- 1) Reminder – LEReC website found here: [http://www.c-ad.bnl.gov/esfd/LE\\_RHICeCooling\\_Project/LEReC.htm](http://www.c-ad.bnl.gov/esfd/LE_RHICeCooling_Project/LEReC.htm).
- 2) Discussion focused on three primary topics:
  - a. The tapered beam pipe insert to replace the cathode assembly.
  - b. The 18mm FPC withdrawal.
  - c. New discussions on how to handle the downstream transition and HOM damper.
- 3) Tapered beam pipe insert:
  - a. Showed latest update on proposed tapered beam pipe insert., shown here and available on the LEReC website:

Follow up requests for the Tue 09/01/2015 meeting:

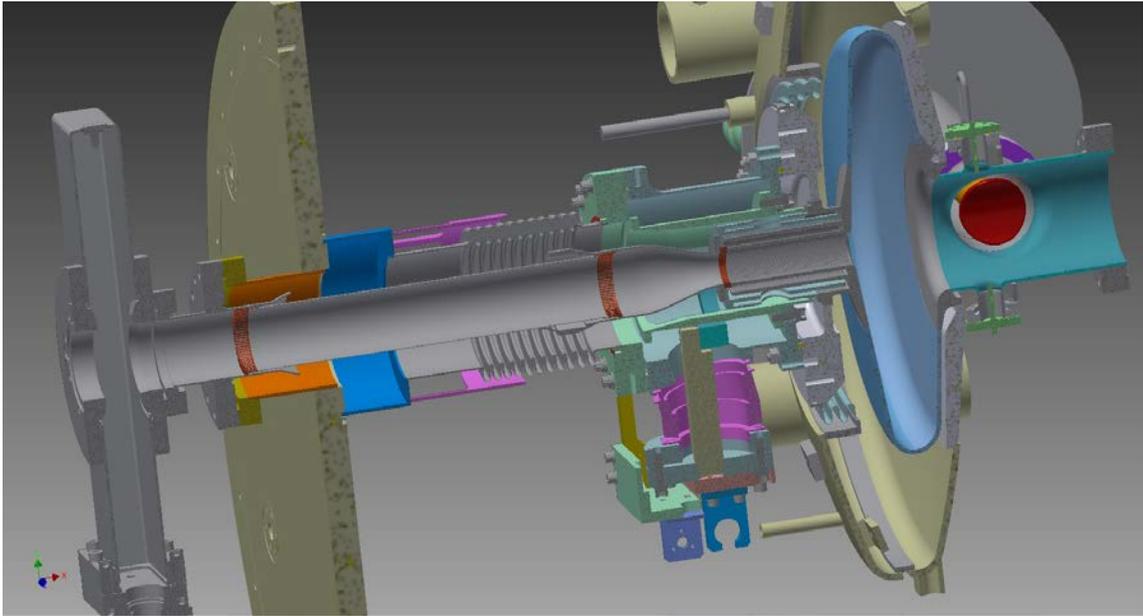
- b. Much discussion on details:
  - i. Much talk on Cu plating inside of beam pipe all the way back to the DC gun.
  - ii. Need a thermal analysis of the heat load from the insert into the 2K cryo.

1. General thought is that it should be low given the low thermal conductivity of the thin wall insert and the RF finger contacts.
    2. The surrounding structure is relatively cold given that the green flange has a 5K intercept.

- iii. The right side tapered part of the insert is physically part of a modified cathode structure.
    1. Clamps in place using existing clamp mechanism.

2. RF seal to Nb pipe still TBD.
      - a. SB confident on getting appropriate yield in the seal at clamping given known survey data of the existing structure.

- iv. Central straight insert is thin wall SS(type?).
    1. Relies on RF spring fingers for contact upstream and downstream.
      - a. Need for give/yield is driven by a ~0.100" centerline misalignment from upstream flange to Nb pipe.

- b. Some concerns expressed even about impedance of fingers, should they be shorter, etc.
  - v. Left side insert and flange assembly are new.
  - vi. Discussion about how the actual insertion process would go.

- vii. Need an RF analysis (impedance/wakefield) of the proposed structure.
    1. Peter T. is swamped and cannot do it.
    2. KSS and Wencan discussion options.

- c. At this stage, the overall design concept seems pretty solid.
  - i. Final discussion at next meeting to decide if Scott can go ahead and start purchasing parts for a prototype.
